ATTACHMENT 4: UPDATE TO S. 3.4.1.3 REGARDING LOCATION OF REPEATER STATIONS

Bipole III Transmission Project

Fibre Optic Repeater Sites

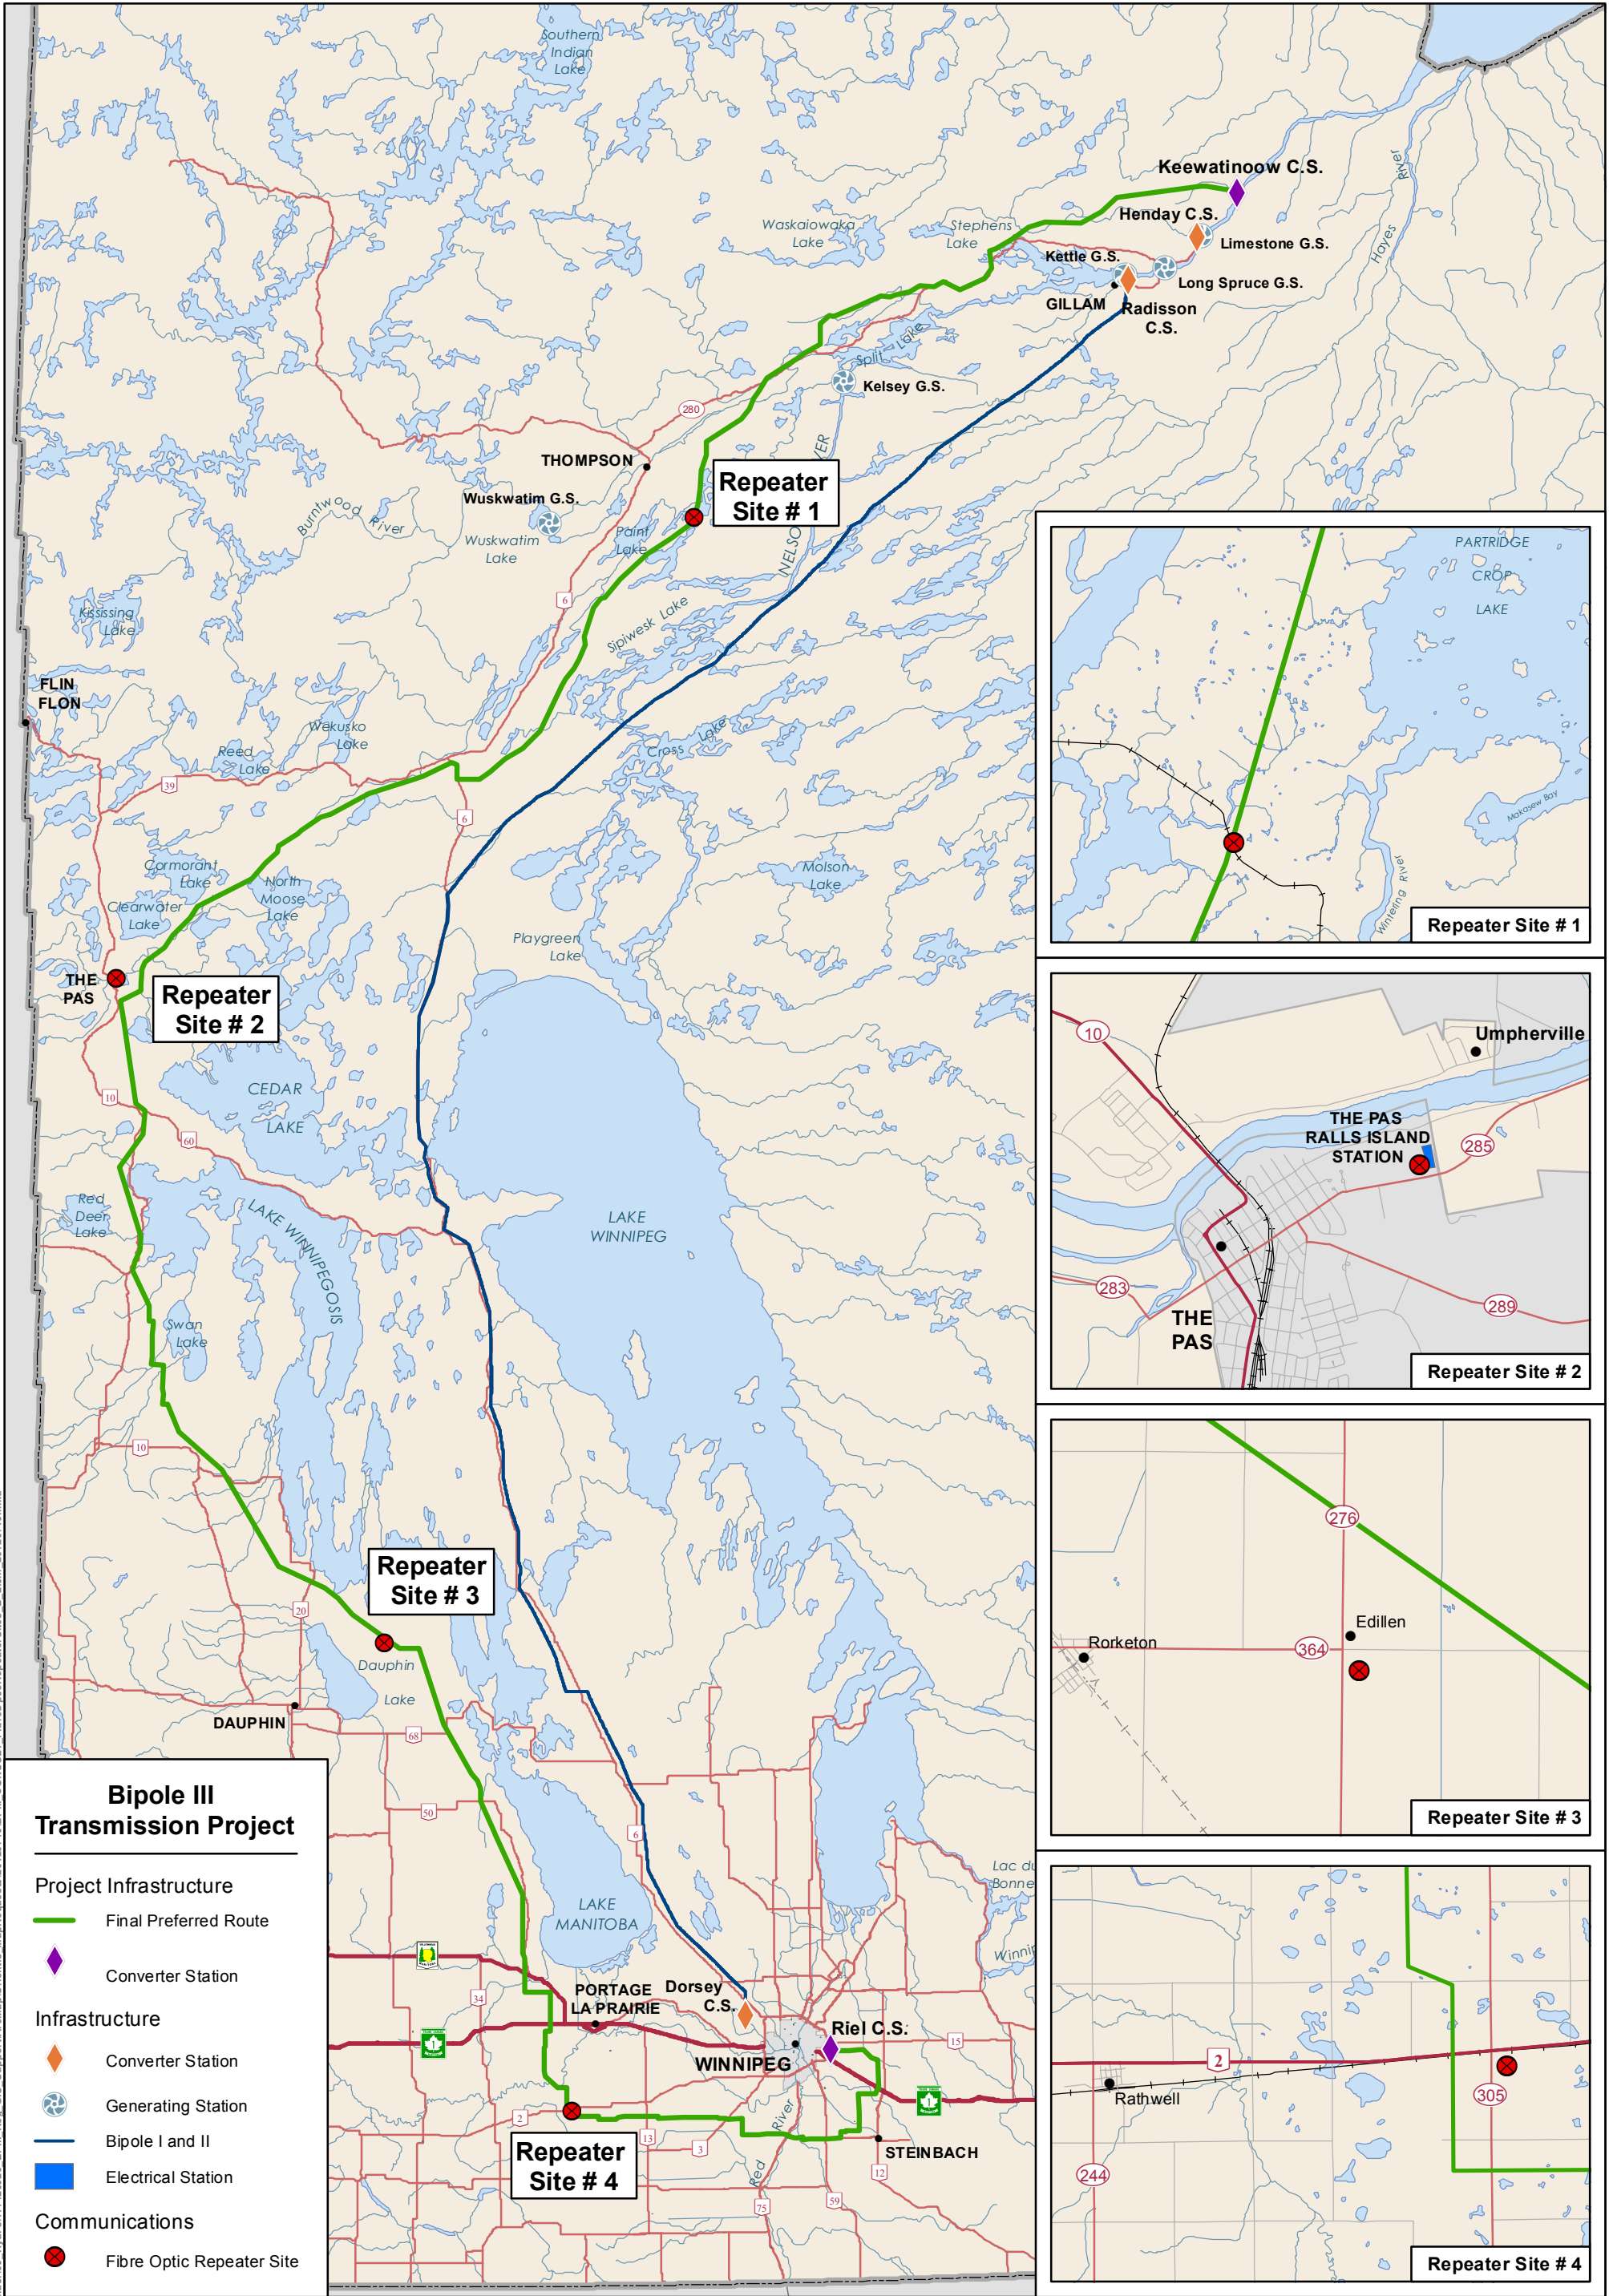
Section 3.4.1.3, page 3-22, paragraphs 2-4 of the Bipole III EIS discusses four repeater stations and their anticipated locations. Since filing the EIS, design has progressed and more specifics related to the number and location of the repeater stations are available. Hence, the following paragraph updates the information in section 3.4.1.3.

Four repeater stations will be required for the Bipole III project. The following Map, entitled “Fiber Optic Repeater Sites” denotes the anticipated locations of each of the repeater stations. Of the four, one station will be located within the confines of an existing transmission facility and the other three will be newly constructed on or adjacent to the Bipole III right of way. One repeater station (the 2nd repeater station along the route) will be housed at the Pas-Ralls Island transmission station, in order to take advantage of existing communications facilities. The remaining three repeater sites will be housed in yet to be developed or new stand-alone sites located within the HVDC line right-of-way, and within 100m to 300m of a transmission tower. The first of these three will be located in the southeast quarter of Section 4 Township 76, Range 1, west of the prime meridian, between Keewatinoow (about 290 km distant along the right-of-way from Keewatinoow) and The Pas-Rauls Island transmission station. The site is near Partridge Crop Lake, roughly 30 km southeast of Thompson. The second new site will be located at the existing Manitoba Hydro Rorketon Station, located at North West quarter of Section 9, Township 28, range 15 west of the prime meridian. The third stand alone site will be located on Municipal land in the southwest corner of Section 13, Township 8, Range 8, west of the prime meridian, about 238 km distant from the second stand alone site. This third stand alone site is located east of the town of Rathwell.
